Final Plat
Post 273 American Legion Addition
SUBDIVISION REPORT

S/D No.: 87-55 Name: POST #273 AMERICAN LEGION ADDITION

POST # 273
AMERICAN LEGION ADDITION

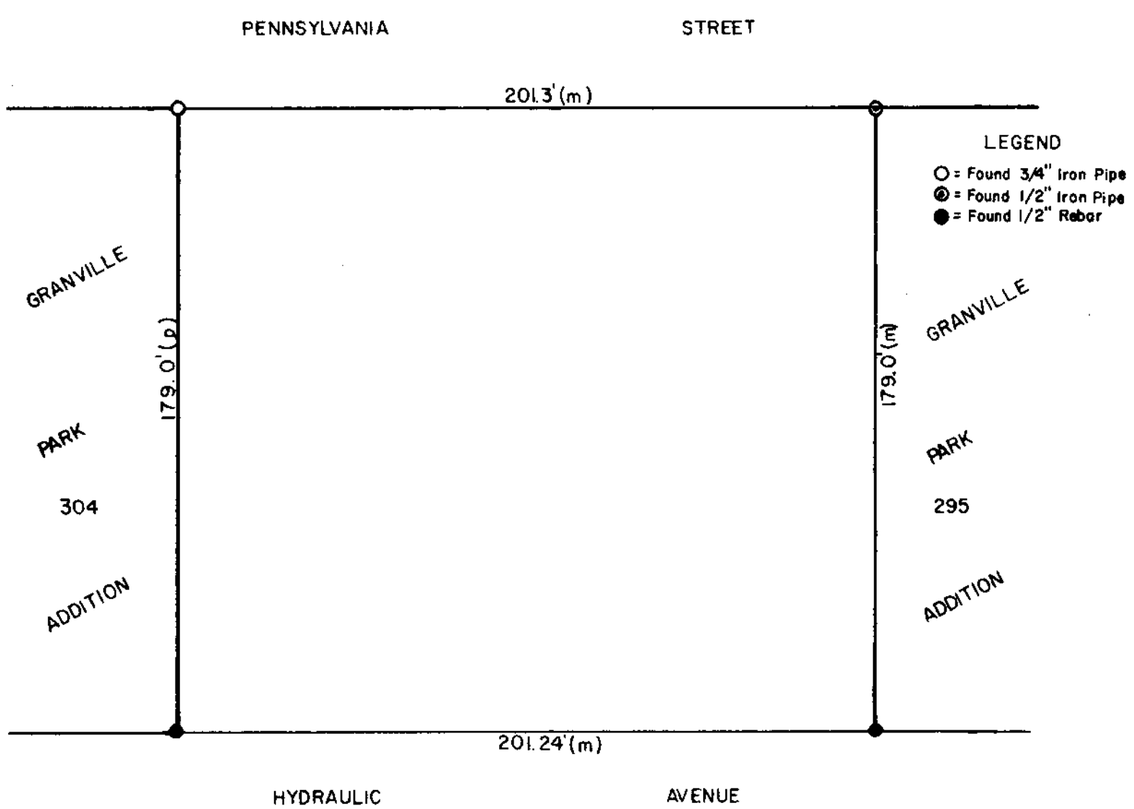
M. Perimeter closure computations shall be submitted with the final plat tracing. Section 5-101(C).

C. The final plat tracing shall indicate the platting of "complete access control" to Pennsylvania across the west line of this lot. The platting of this access control was a requirement of the associated zone case.

D. The plattor's text shall be amended to reference the platting of access control to Pennsylvania Avenue.

E. The final plat tracing shall indicate a 35-foot building setback from both Pennsylvania and Hydraulic.

F. The centerlines and existing half-street rights-of-way for both Pennsylvania and Hydraulic shall be indicated on the final plat tracing.

G. The final plat tracing shall reference a tie point to a previously platted lot corner or section corner.

H. A lot number, lot 1, shall be indicated on the final plat tracing.

I. The final plat tracing shall indicate angles or bearings for the perimeter of this plat.
